ADDENDUM NO. 2

Dated: December 17, 2018

**NW NEIGHBORHOOD PARK
PROJECT NO. 2015-11**

E2.00

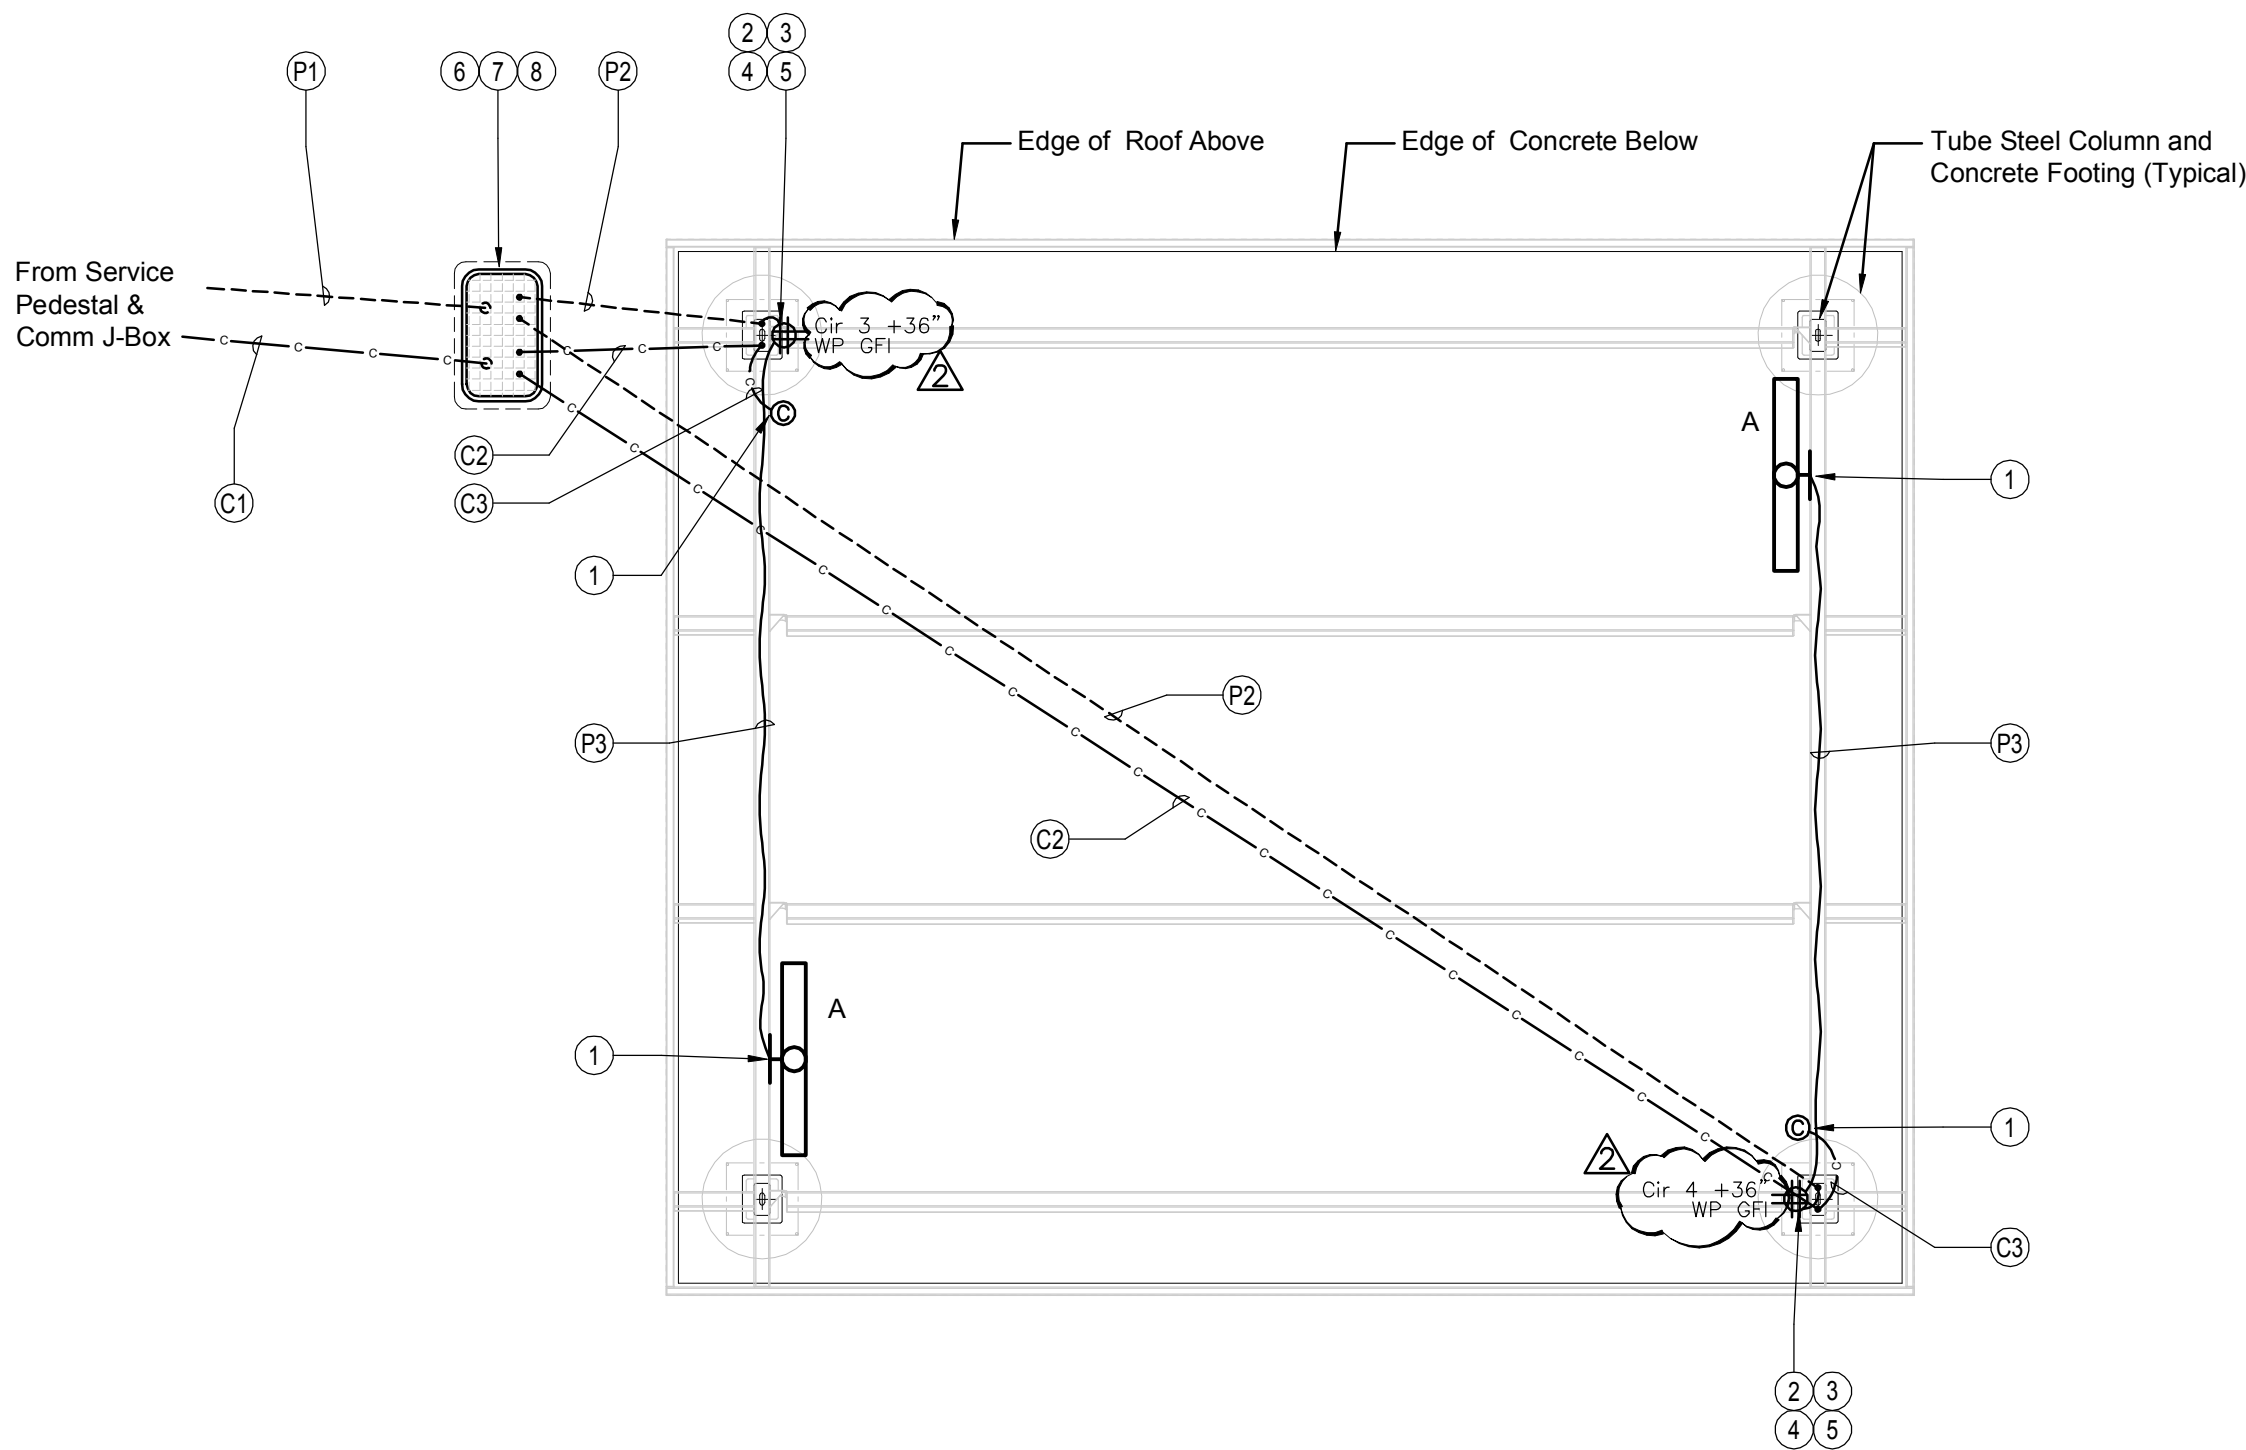
1. Replace Sheet E2.00 with Revised Sheet E2.00 dated 12/14/18 in the revision block. The Legend has been added to this sheet and is clouded.
